Appendix 2: Pre-lodgement and Affected Persons Consultation

This consultation summary has been prepared in support of the Substantive Application (Application) for Mt Welcome. Section 29 of the Fast Track Approvals Act (FTAA) requires that the applicant consult with the persons and groups referred to in s11 of the FTAA prior to lodging the Substantive Application.

The purpose of this Consultation Summary Report is to provide an overview of the consultation undertaken by the Applicant, Pukerua Property Group Limited Partnership (PPGLP), prior to lodging this Substantive Application.

Park location

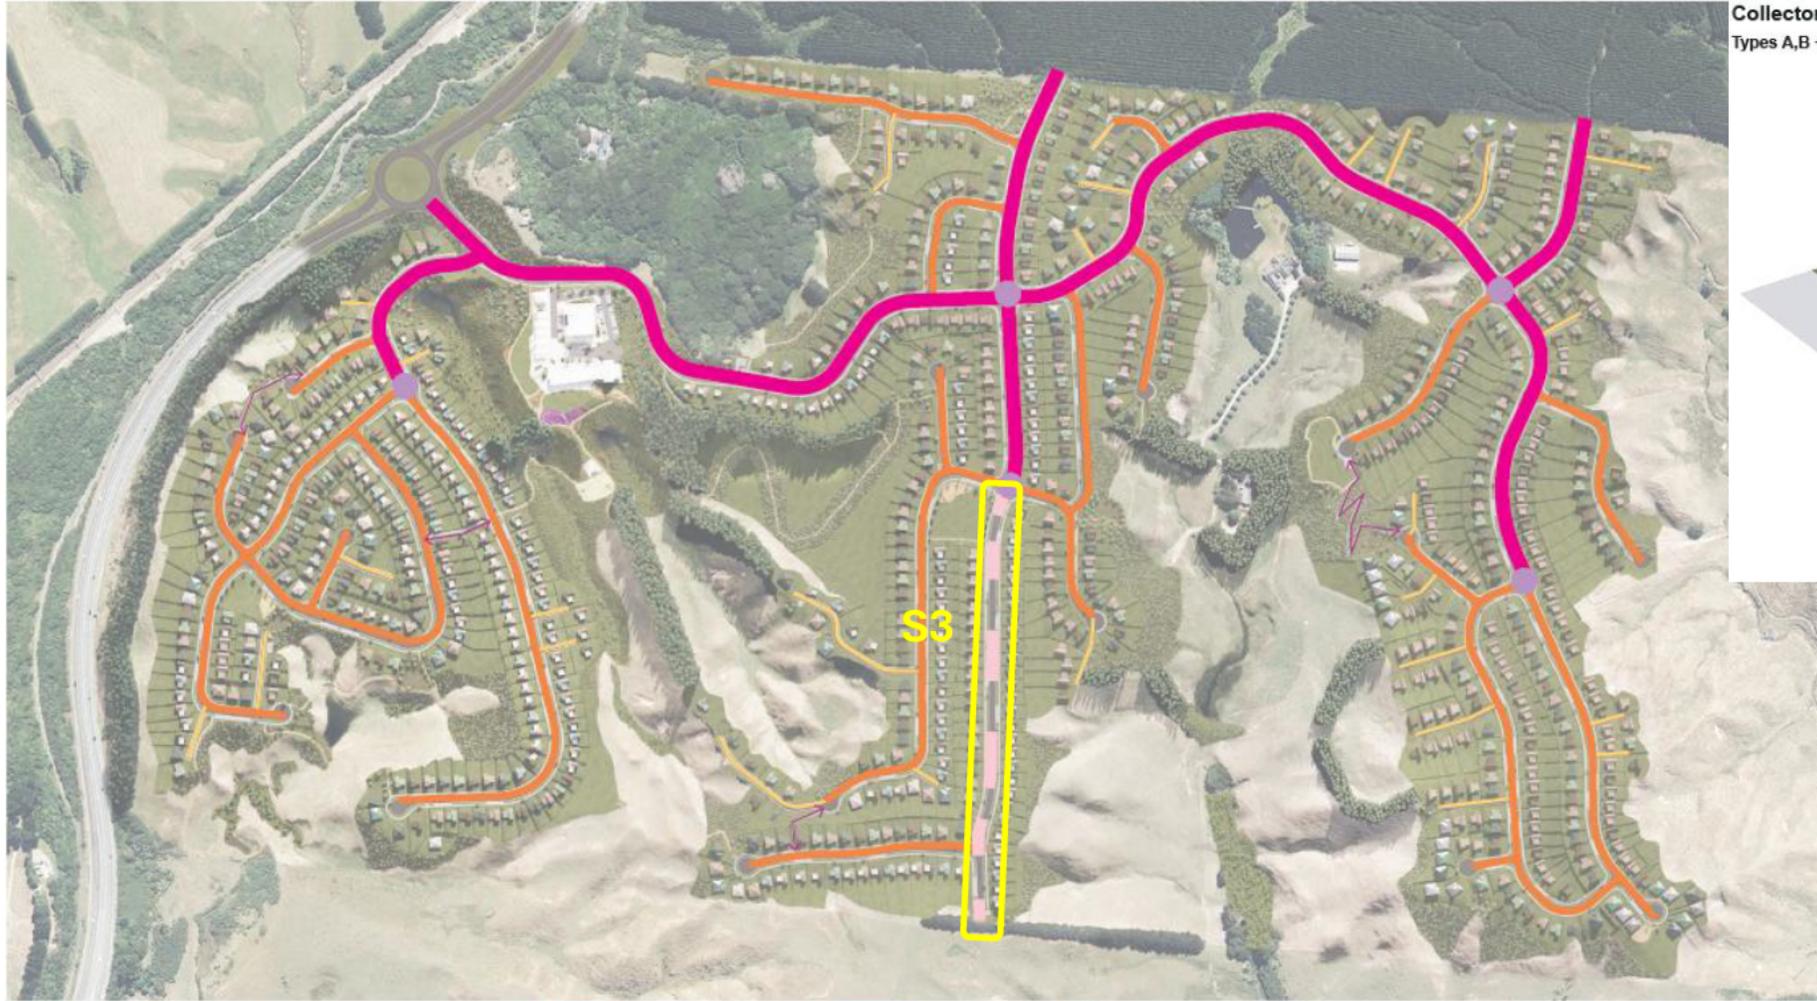
- P1:** Locate this park closer to the centre of the Lucas Block where it will be more readily accessible for residents on foot and add amenity and value to the more lots that will be close to it.
- Also simplifies need to allow for future street connection FC4 to the south through a proposed park.

Collector Roads
Types A,B + C

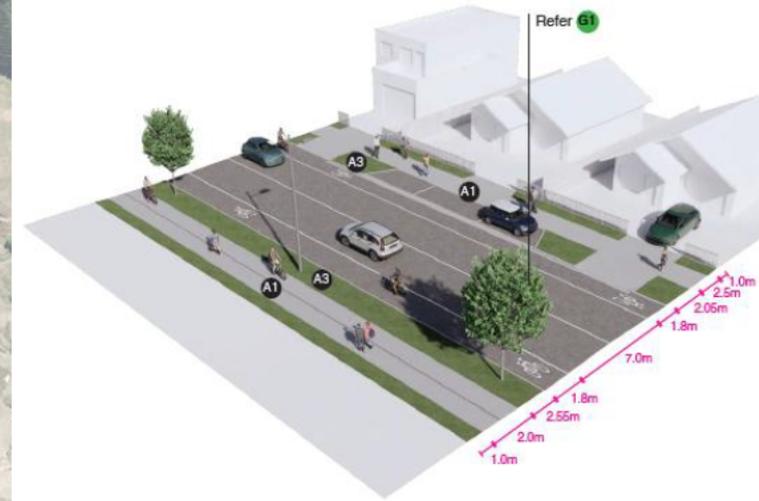
As noted on Sk1:

- S3:** Change status of 'Local Street' to 'Collector Road'
 - This is a main connector between the Muri Block to the north and the Scaife block to the south, and is the only part of the main network without cycle lanes. This should be extended to address the network.

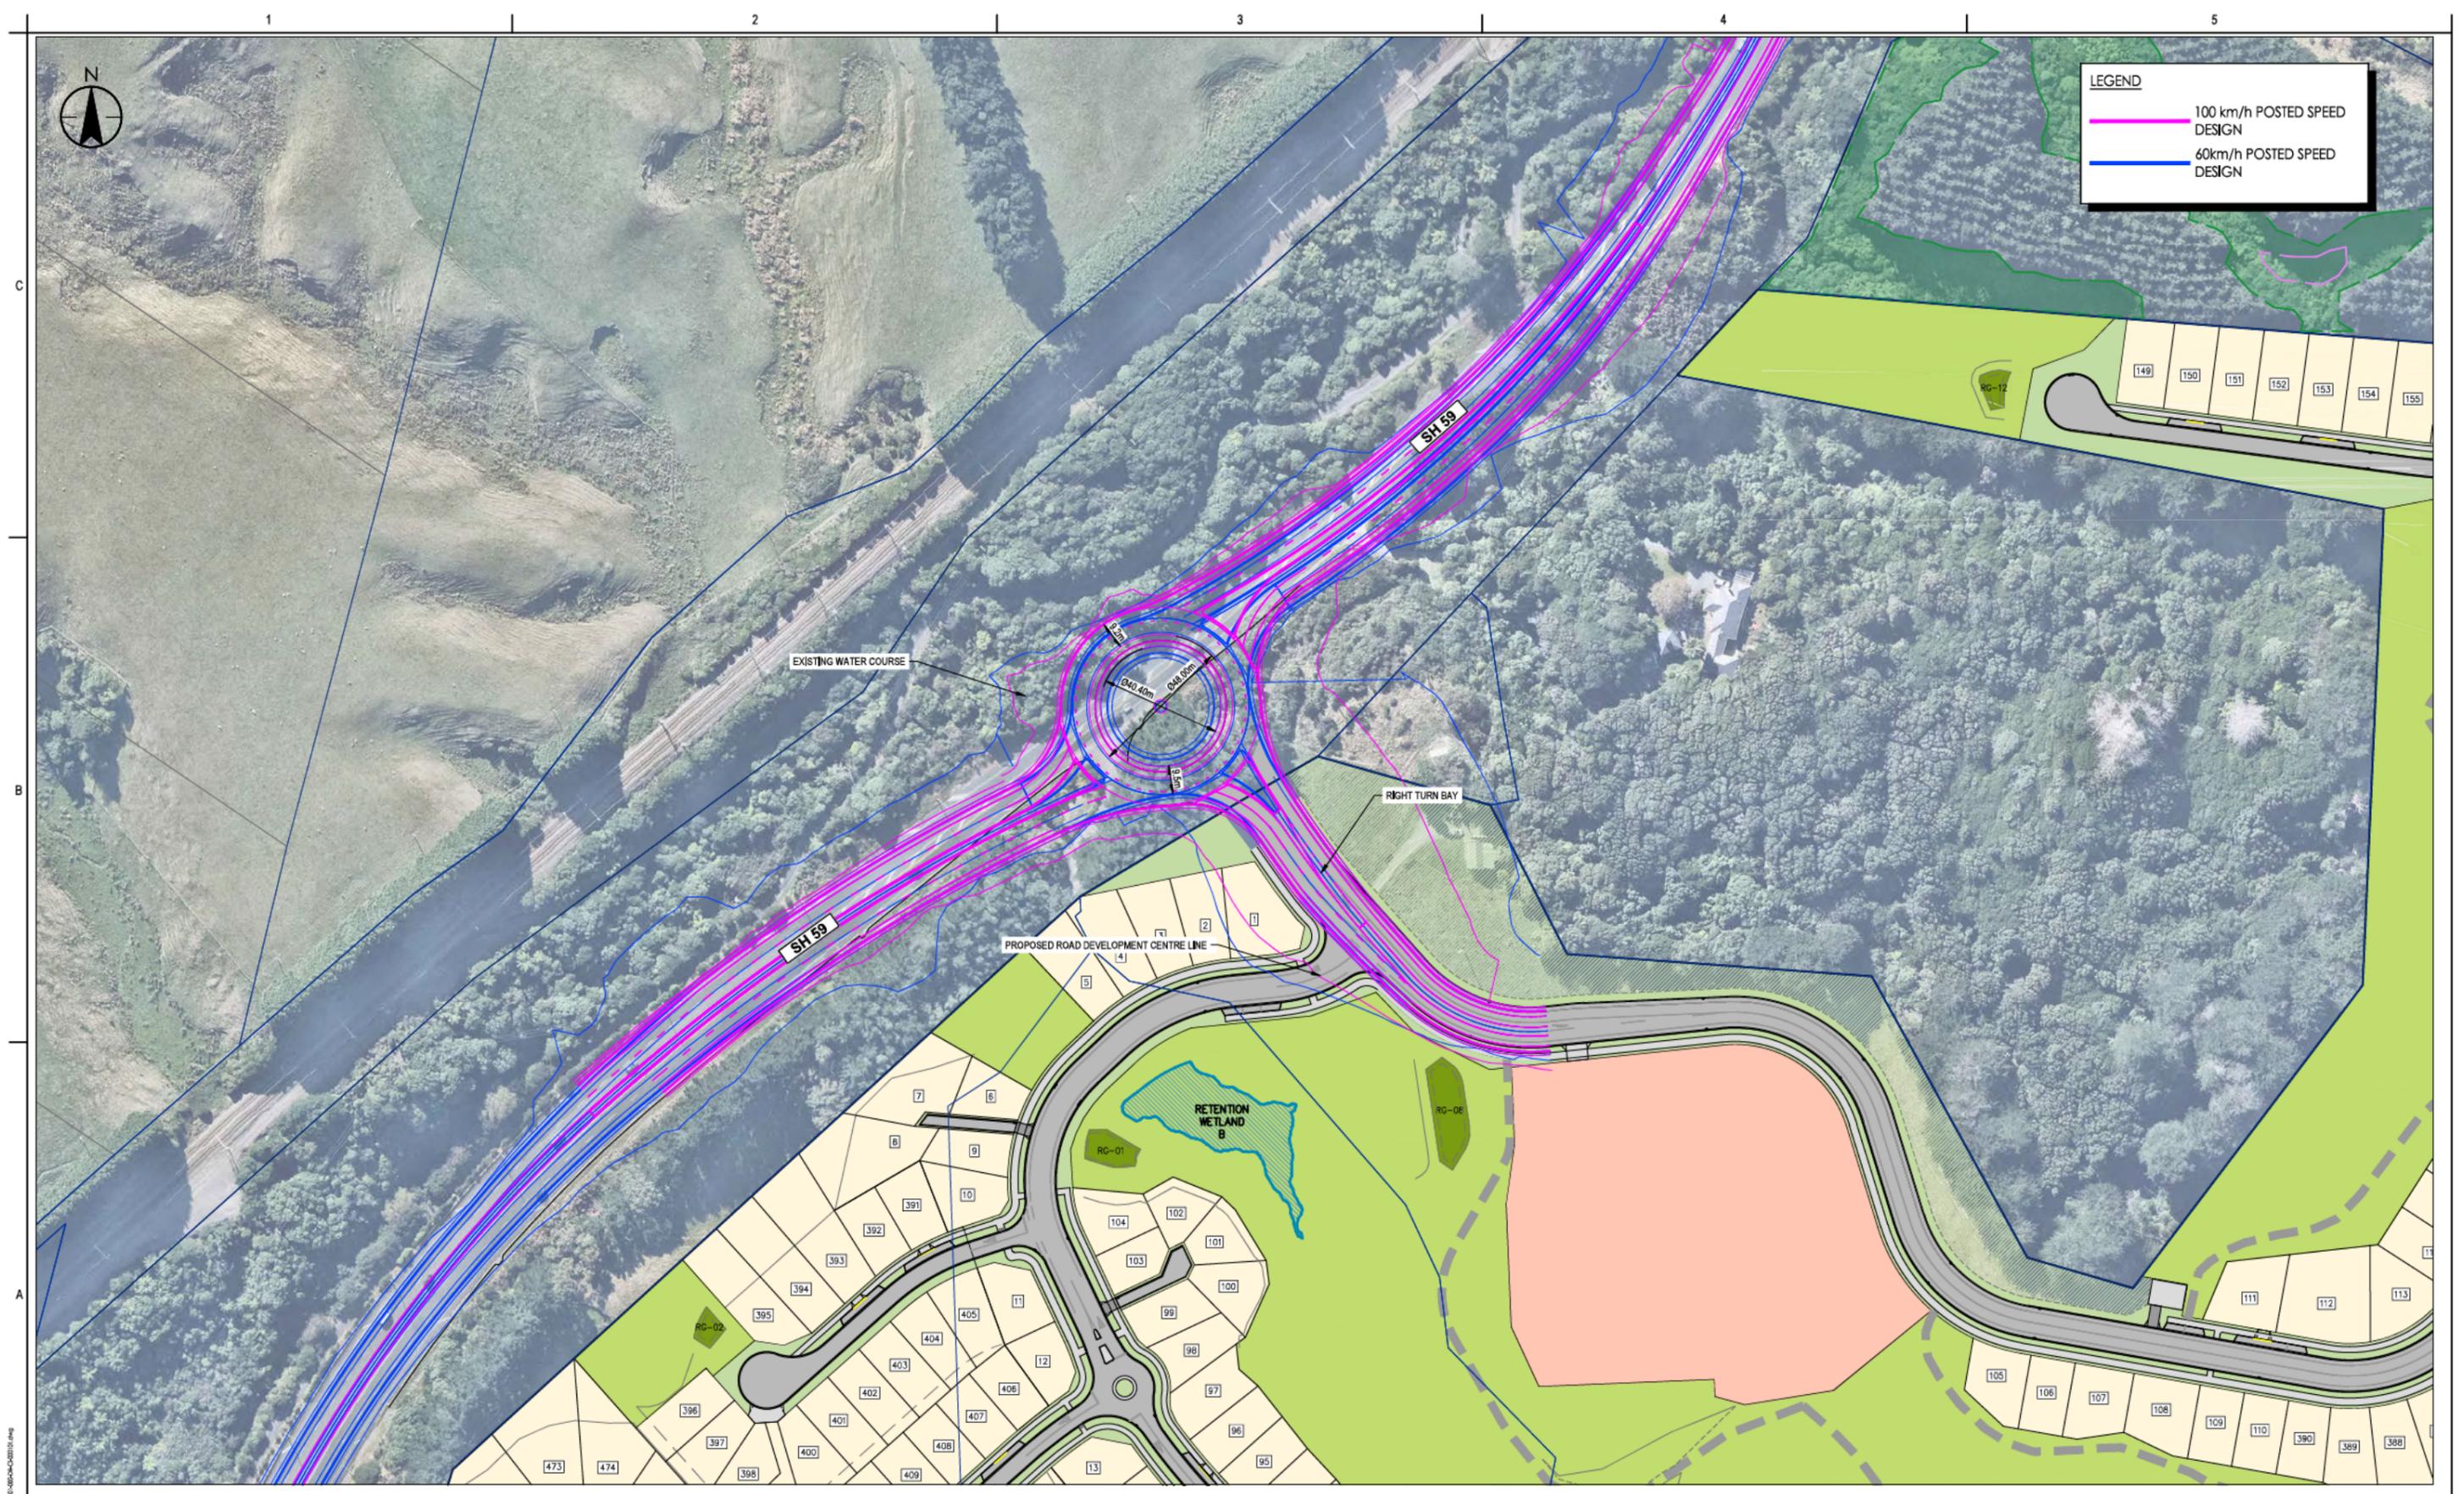
An indicative concept is attached which incorporates the following design elements:

- new right turn bay provided for SH59 NB traffic accessing the Site;
- the SH59 NB 2 to 1-lane merge is moved south to allow merge to terminate earlier, prior to the new right turn bay taper commencing;
- realignment of the existing Site access road to provide a 90-degree approach angle to the Highway, to assist sightlines and vehicle tracking; and
- some vegetation clearance on the eastern side of the Highway, south of the access, to ensure 'Safe Intersection Sight Distances' are achieved for all traffic movements to / from the Site.
